ISO/IEC 11801-1

INFORMATION TECHNOLOGY – GENERIC CABLING FOR CUSTOMER PREMISES

Part 1: General requirements

CORRIGENDUM 1

Figure 1 – Relationships between the generic cabling documents produced by ISO/IEC JTC 1/SC 25

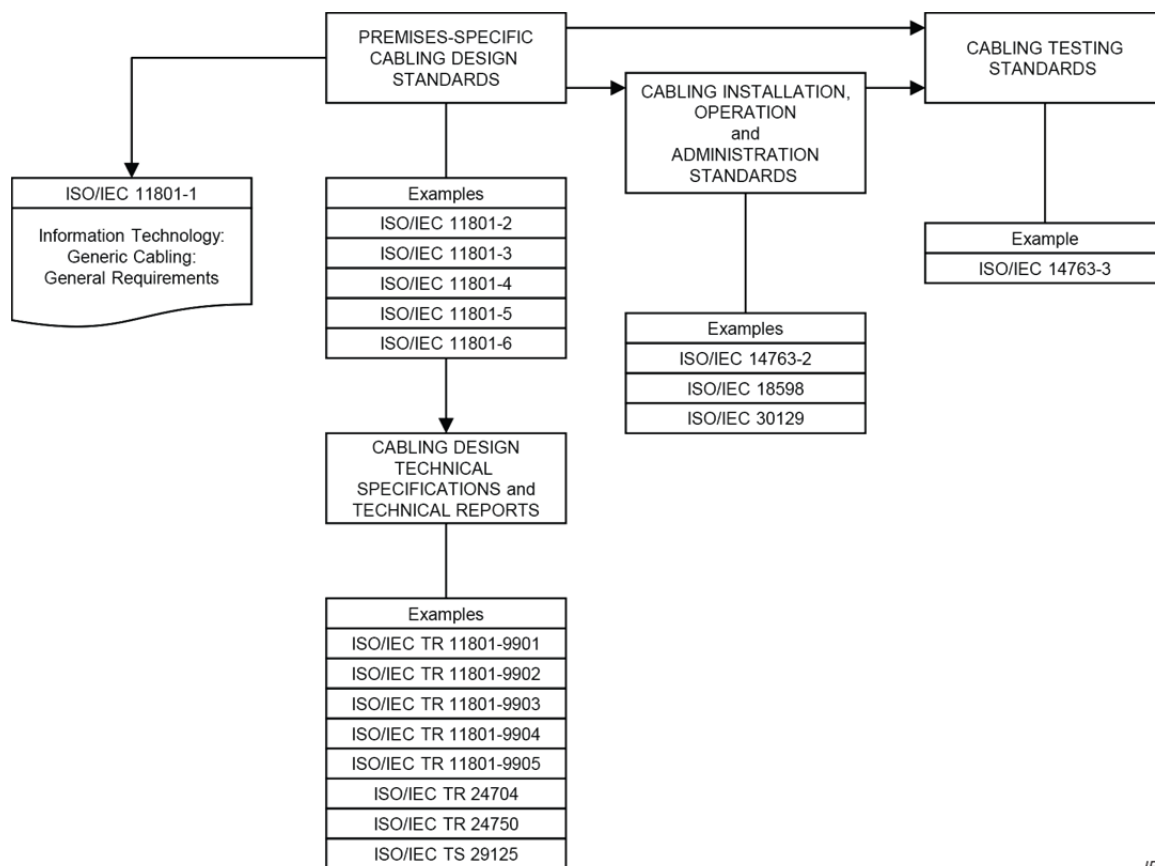
Replace the figure graphic with the following new figure graphic:

Figure 5 – Equipment and test interfaces

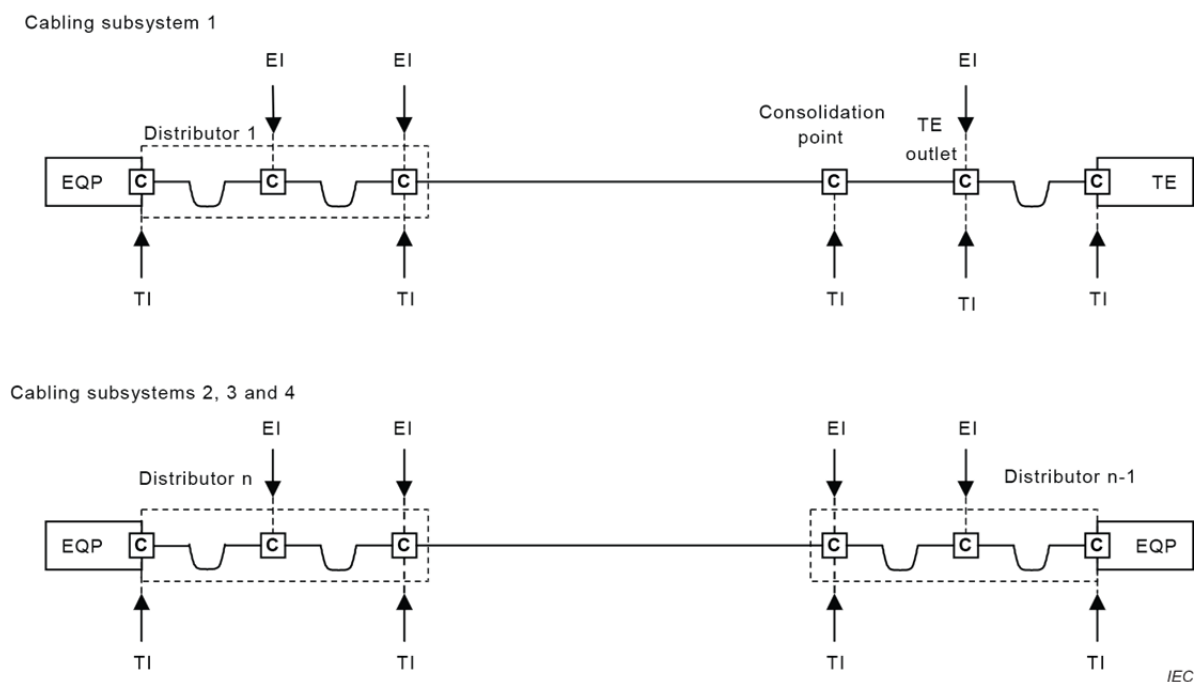
Replace the figure graphic with the following new figure graphic:
